RE: Technical Review: "Compliance Activities Workplan for the Mixed Waste Landfill" - Sandia National Laboratory - June 1991

Review of: Technical Review: "Compliance Activities
Workplan for the Mixed Waste Landfill" Sandia National Laboratory -
June 1991
Prepared For: DOE AL
Prepared By: ER TSO
Reviewers: M. T. Gerety and W.J.Wenzel

Figure 6 SOIL BORING LOCATIONS AT MWL

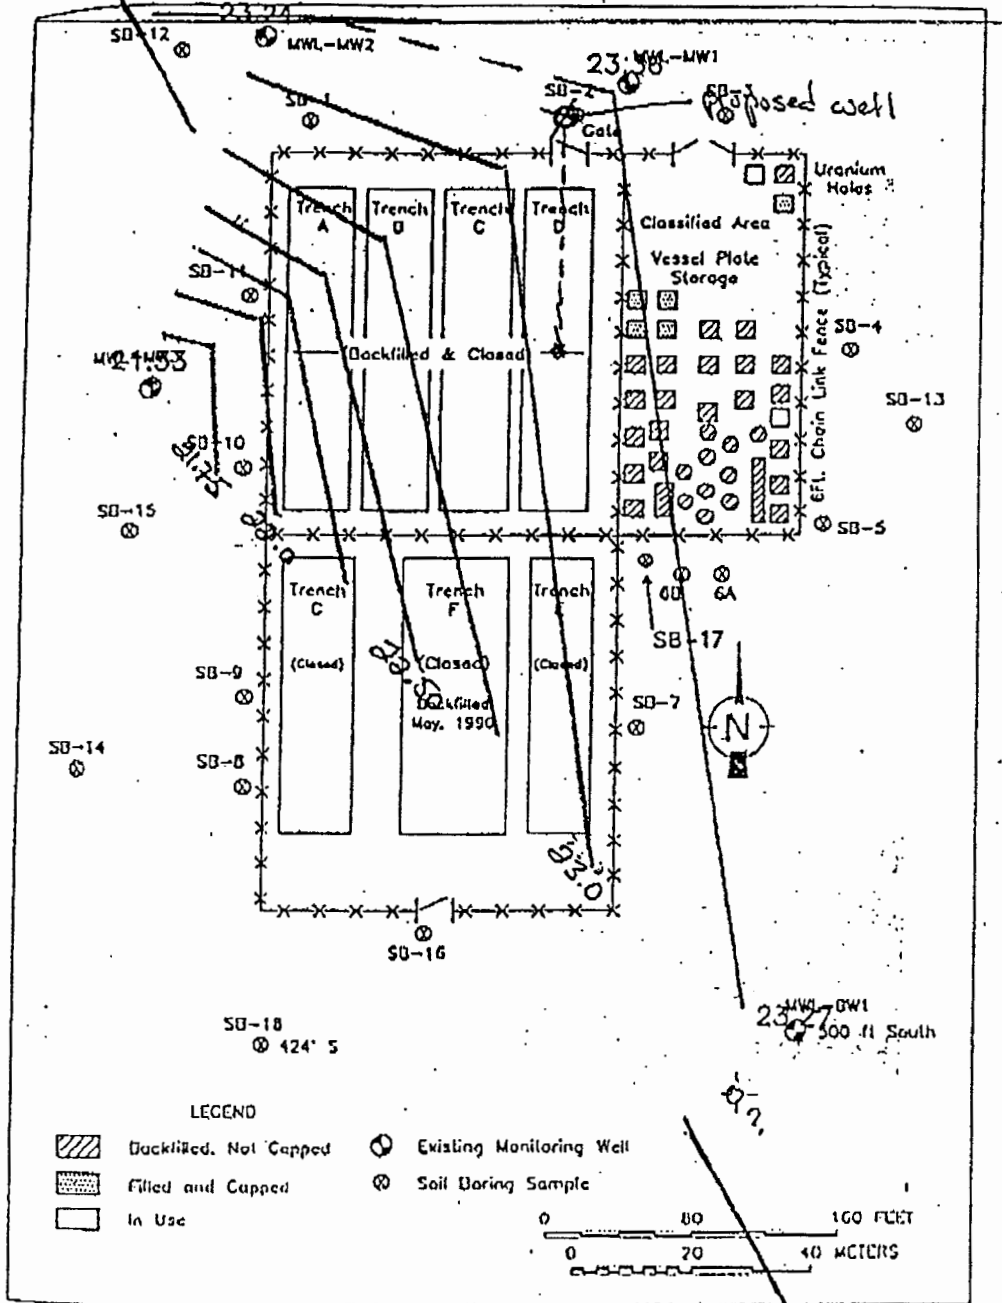
- 6/1/5 The text indicates that the hydrologic data obtained from the current monitoring well system fails to indicate if the placement of wells allows for adequate downgradient coverage. However, data presented in this document (Appendix A, Water Level Elevations) consistently show that the monitoring well network has only one well downgradient and three wells, none of which could be considered up-gradient (see Attachment 1). They could however, be considered background wells.

Axis of possible step fault - downdropped block to the west.

water level contours from 3/14/91 - these data indicate that there are three upgradient and one downgradient well.
